Well Name: BLACKROCK B	Well Location: T26N / R11W / SEC 8 / NWSW / 36.500626 / -108.033173	County or Parish/State: SAN JUAN / NM
Well Number: 1	Type of Well: OIL WELL	Allottee or Tribe Name:
Lease Number: NMSF078899	Unit or CA Name:	Unit or CA Number:
US Well Number: 300450593200S1	Operator: DUGAN PRODUCTION CORPORATION

Type of Submission: Notice of Intent	Type of Action: Plug and Abandonment
Date Sundry Submitted: 04/03/2025	Time Sundry Submitted: 07:34
Date proposed operation will begin: 04/28/2025

Notice of Intent – Plug and Abandonment

BLM - FFO - Geologic Report**Date Completed**

Current Wellbore Schematic

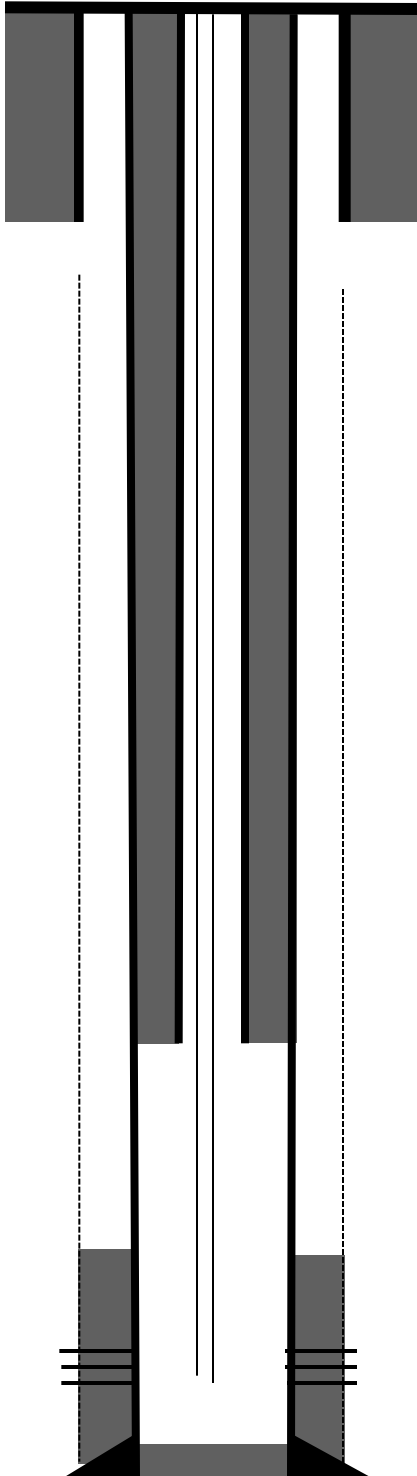
-The perforations are labeled as Dakota perfs in the Formation Top list. Elsewhere in the procedure and the Planned and Current P&A Schematics the perfs are identified as Gallup.

Planned P & A Schematic

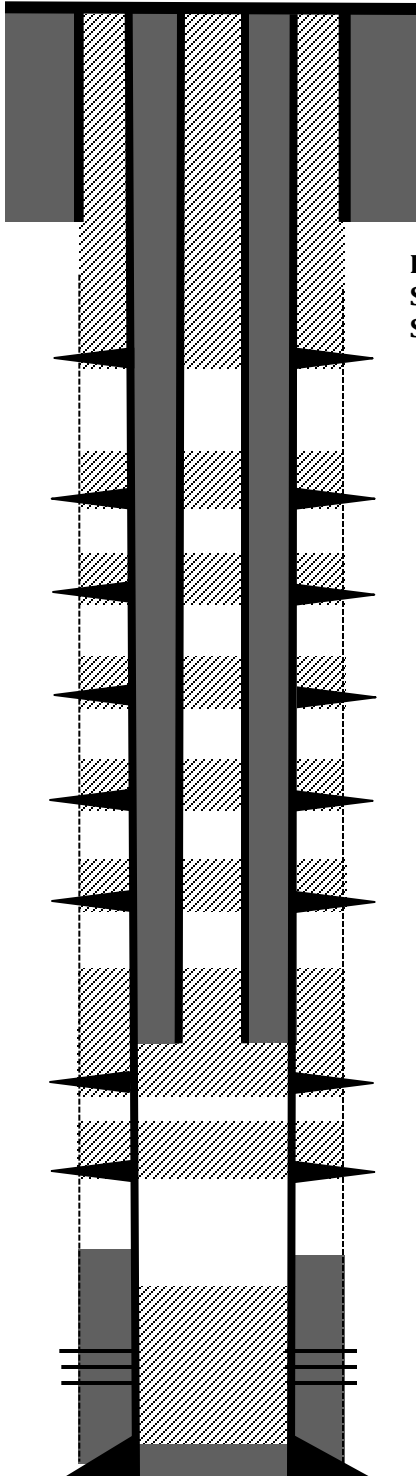
-The Plug 1 figure shows a BOC of 5359' in the Planned P&A Schematic while the description in the Planned P&A Schematic and the Procedure both include a BOC of 5324'.

-Modify Plug 2 to account for the BLM geologist's picks for the Mancos. Move the plug BOC to 4260' and the TOC to 4110'. Alternatively, the plug may be combined with Plug 3 with a TOC of 4056'.

-Modify Plug 4 to account for the BLM geologist's picks for the Cliff House. Move the plug BOC to 3071' and the TOC to 2921'.

-Modify Plug 7 to account for the BLM geologist's picks for the Pictured Cliffs. Move the plug BOC to 1502' and the TOC to 1352'.

-Modify Plug 8 to account for the BLM geologist's picks for the Fruitland. Move the plug BOC to 1050' and the TOC to 900'.

Created By	Condition	Condition Date
mkuehling	NMOCD agrees with BLM on formation tops except for PC=1471 adjust plugs accordingly - Notice has been given on moving on April 14, 2025 - Monitor string pressures daily report on subsequent - Operator has requested not running log and that they will perforate every plug which is approved -	4/14/2025
